DAWES CREEK SUBDIVISION

APPLICATION NUMBER 9 DATE May 1, 2003

REQUEST Subdivision

DETAIL SITE PLAN

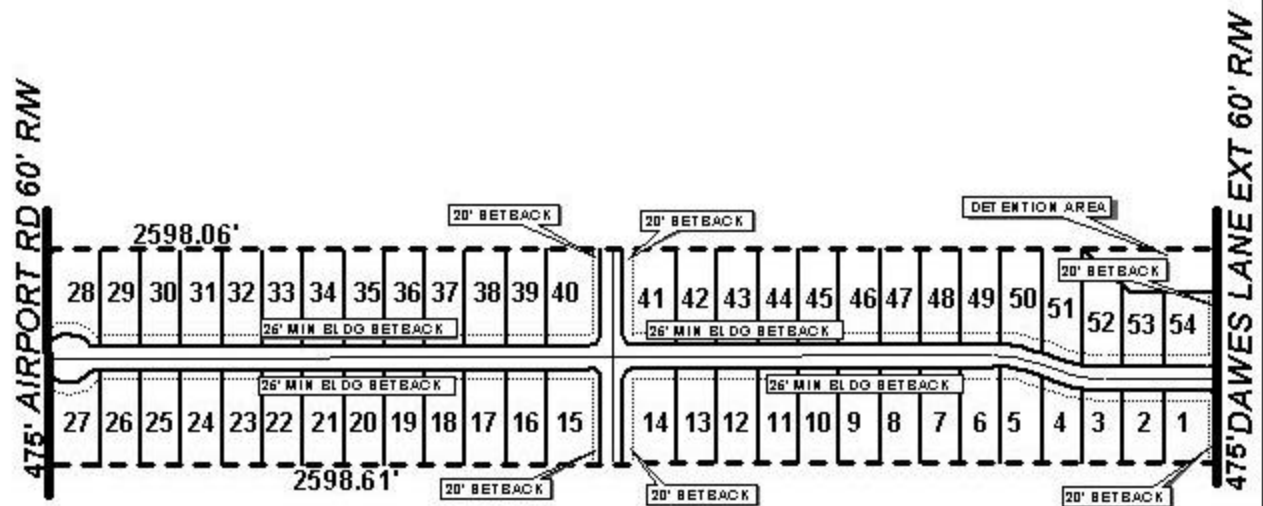
Airport Road, which is unpaved and has an existing right-of-way of 60-feet, is shown as a major street on the Major Street Plan, and as such requires a 100-foot right-of-way; therefore, dedication of sufficient right-of-way to provide 50-feet from the centerline should be required. As a means of access management, the subdivision should be denied access to Airport Road until it is improved to County standards.

As proposed, the street would be approximately 2,600' in overall length. However, the applicant is providing street stubs to the North and South, located at the approximate midsection of the proposed street. Due to the proposed street length, the provision of two traffic-calming devices (one between Dawes Lane Extension and the street stub and one between street stub and Airport Road) with the location and design to be approved by County Engineering should be required.

As proposed, Lots 1 and 54 have frontage along Dawes Lane Extension and the new street and Lots 27 and 28 have frontage along Airport Road and the new street; therefore, the placement of a note on the final plat stating that Lots 1 and 54 are denied direct access to Dawes Lane Extension and Lots 27 and 28 are denied direct access to Airport Road should be required.

There is an area labeled for detention but not labeled as a common area; therefore, a note identifying this area as detention, as well as a note stating that the maintenance of the common area is the responsibility of the property owners, should be required on the final plat.

This site is located in the County, thus a note should be placed on the final plat stating that any lots which are developed commercially and adjoin residentially developed property must provide a buffer in compliance with Section V.A.7., of the Subdivision Regulations.

The plat meets the minimum requirements of the Subdivision Regulations and is recommended for Tentative Approval subject to the following conditions: 1) the dedication of sufficient right-of-way to provide 50-feet from the centerline of Airport Road; 2) the placement of a note on the final plat stating that the subdivision is denied access to Airport Road until it is constructed to County standards; 3) the placement of a note on the final plat stating that Lots 1 and 54 are denied direct access to Dawes Lane Extension; 4) the placement of a note on the final plat stating that Lots 27 and 28 are denied direct access to Airport Road; 5) the area labeled as detention also be labeled as common area; 6) placement of note stating that the maintenance of all common

areas is the responsibility of the property owners; and 7) the placement of a note on the final plat stating that if any property is developed commercially and adjoins residential property, a buffer will be provided in compliance with Section V.A.7. of the Subdivision Regulations.
